This is a draft proposal for the Global Technical Regulation (GTR) „head restraints“, to specify some more alternatives for non use positions of head restraints in rear seats. The proposal is based and integrated in the current draft text of the GTR head restraints from September 2005.

Draft text for GTR:

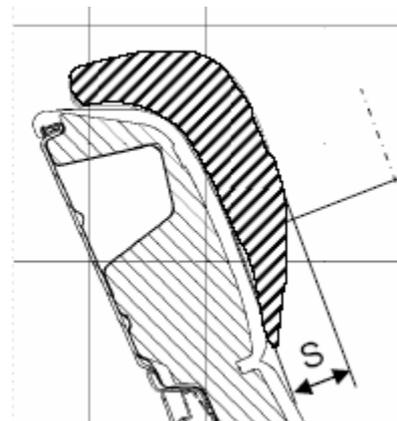
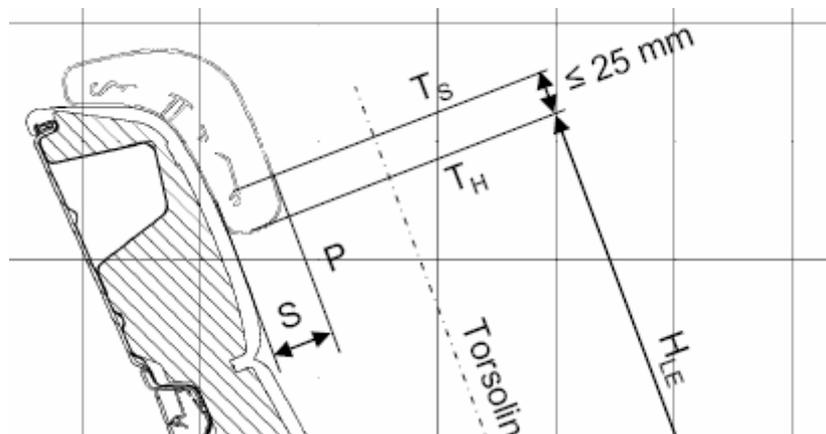
For the alternative “discomfort metric” there was added an additional criteria, where the thickness of the head restraint is measured in detail. The new criteria of measuring the thickness of the head restraint [25 mm] (to be defined) above the lower edge (see below) shall prevent some strange shapes or a very smooth lower edge, which would not be felt as discomfort for the occupant anymore.

“strange” shape, leading to more thickness of head restraint

“smooth” lower edge, may not be recognized as discomfort

new criteria: measuring of thickness S [25 mm] above lower edge

5.3.2.2 Discomfort metric: When measured in accordance with Annex 10 §1, the lower edge of the head restraint (H_{LE}) must be not more than [460 mm], but not less than [250 mm] from the R-Point and the thickness S shall not be less than [25 mm].

Figure 4

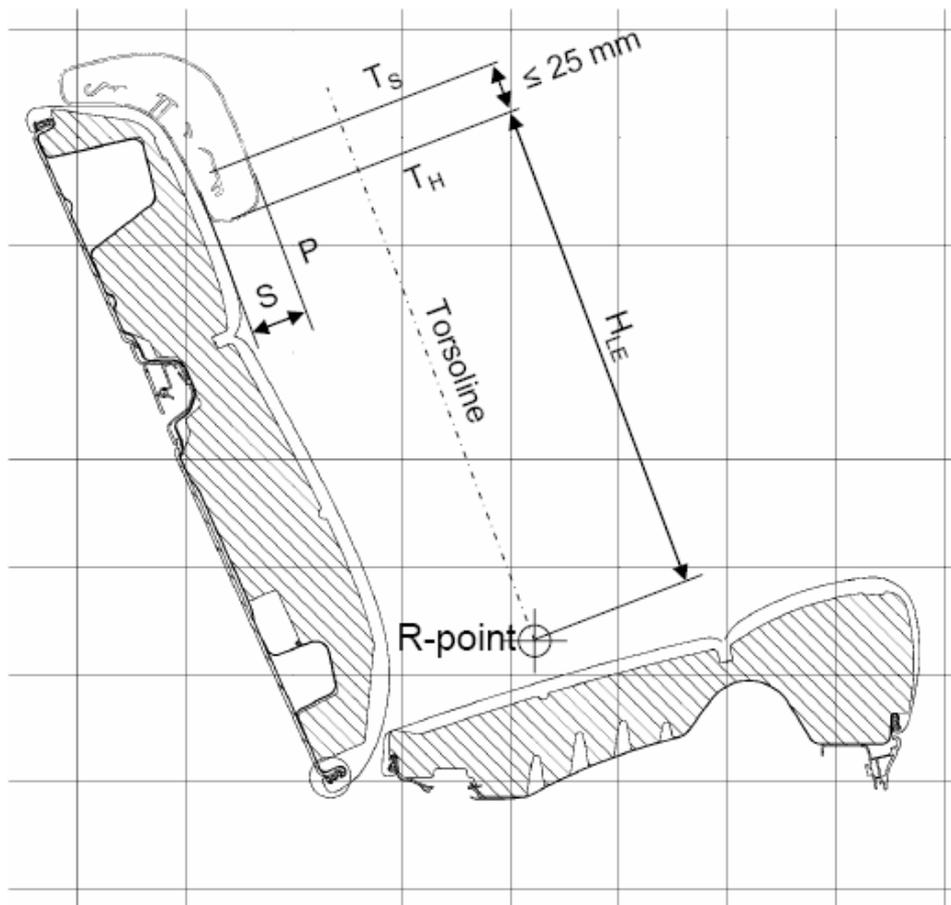
- 1.4 Determine the thickness S of the lower edge of the head restraint as shown in Figure 4:
 - 1.4.1 The projection of the reference line of the manikin is, in the seat concerned, drawn in the plane specified in paragraph 1.1 above. A tangent T_S is drawn above and parallel to the tangent T_H , as specified in 1.3.2, with a distance of not more than *[25 mm]* above. A parallel P to the torso reference line passing through the intersection of tangent T_S with the surface of the head restraint is drawn in the same plane. The distance " S ", measured perpendicular to the torso reference line, from parallel P to the surface of the seat back at this position is the thickness to be taken into consideration in implementing the requirements of paragraph 5.3.2.2 of this regulation.
